**Regulatory Oversight Report on the
Use of Nuclear Substances in
Canada: 2019 and Class IB
accelerators in Canada: 2018-2019**

**SUBMISSION BY THE CANADIAN ENVIRONMENTAL LAW ASSOCIATION
TO THE CANADIAN NUCLEAR SAFETY COMMISSION REGARDING THE
REGULATORY OVERSIGHT REPORT ON THE USE OF NUCLEAR
SUBSTANCES IN CANADA: 2019 AND CLASS 1B ACCELERATORS**

October 13, 2020

**Prepared by:
Kerrie Blaise, Legal Counsel**

Figure 1: Ensuring adequate provision for protection of the environment

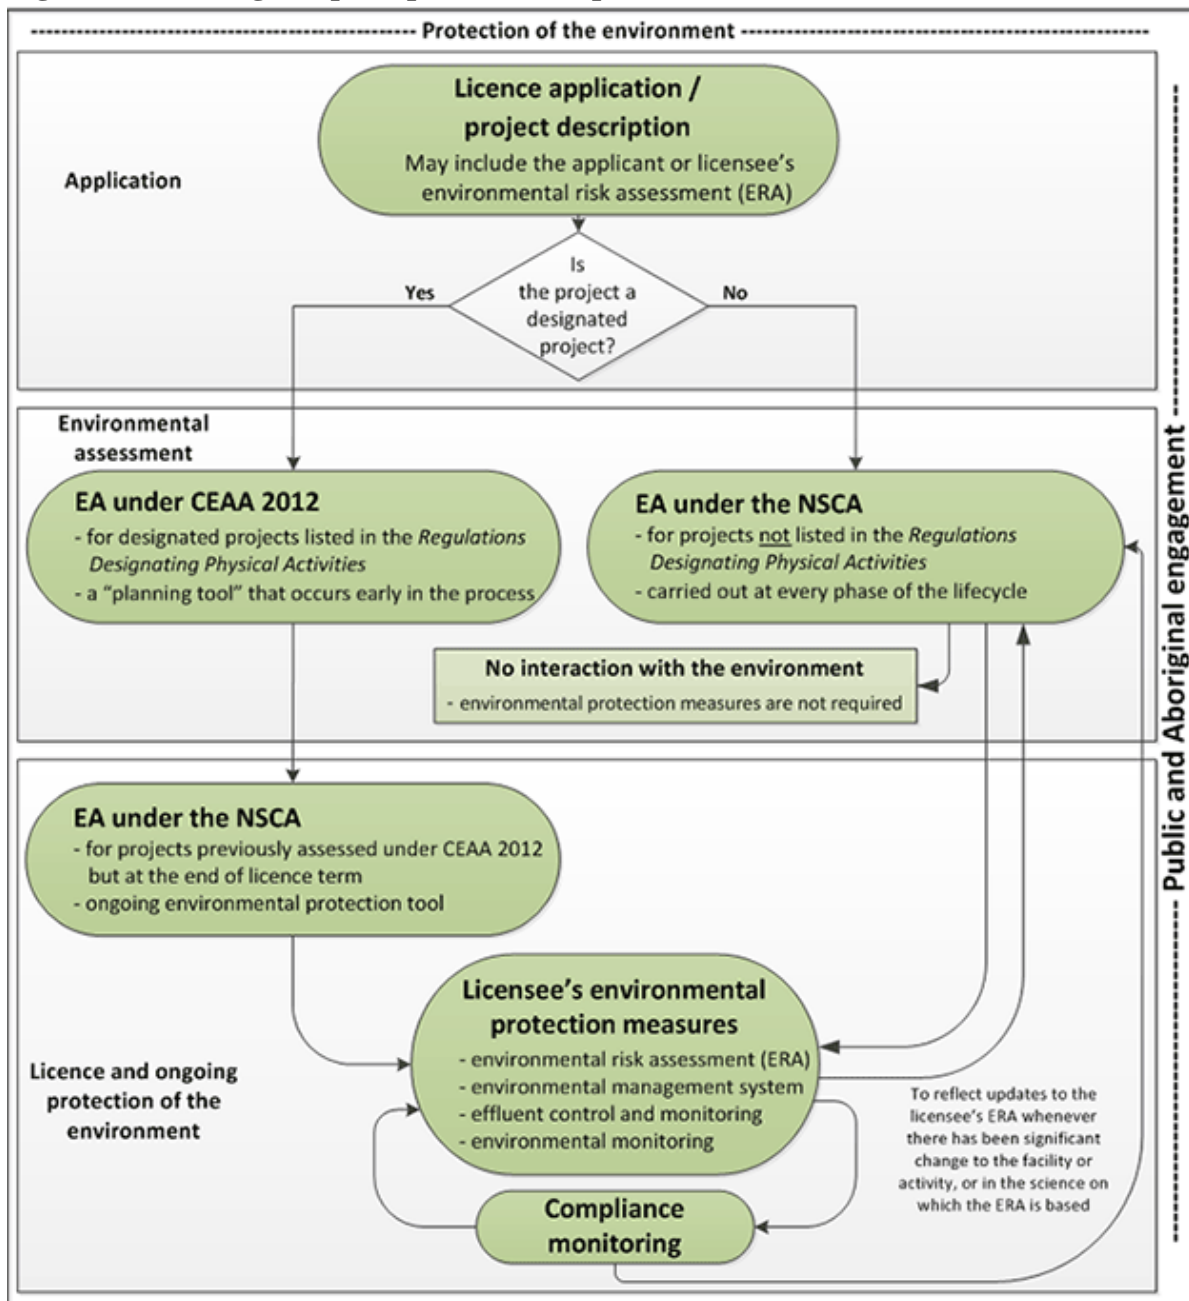
The CNSC's environmental protection framework set out in REGDOC-2.9.1, details compliance monitoring as part of the CNSC's ongoing strategy to the protect the environment. As Figure 1 of REGDOC 2.9.1 displays (copied below), public engagement – displayed on the Y axis - and the protection of the environment – displayed on the X axis - are standard metrics regardless of

stage (ie. application, environmental assessment, licensing).¹⁶ Per REGDOC-2.9.1, CELA submits that this ROR would have been an ideal opportunity for CNSC Staff to reflect on licensees' Environmental Risk Assessments (ERA), compliance with licence conditions pertaining to environmental protection and whether there had been any changes made to the facility or activity upon which the licensees ERA is based.

Furthermore, CELA submits the fulfillment of the CNSC's commitment to publicly engage on environmental protection, as set out in REGDOC-2.9.1, cannot be met by way of the proponent's public information and disclosure obligation. While the ROR states that Class 1B accelerators have a responsibility to inform the public about their nuclear facilities and "ensure that timely information about the health, safety and security of persons and the environment and other issues associated with the nuclear facility are effectively communicated," (emphasis added) the sharing of information does not meet the threshold for engagement committed to in REGDOC-2.9.1.

RECOMMENDATION NO. 9: The Commission should discuss how the ROR process meets the "public engagement" requirement set out in REGDOC-2.9.1. As drafted, the ROR does not contain a critical review or discussion of licensee environmental protection actions. Thus, without data or findings supporting how conclusions in the ROR specific to environment protection are reached, the public's ability to engage with such matters is limited.
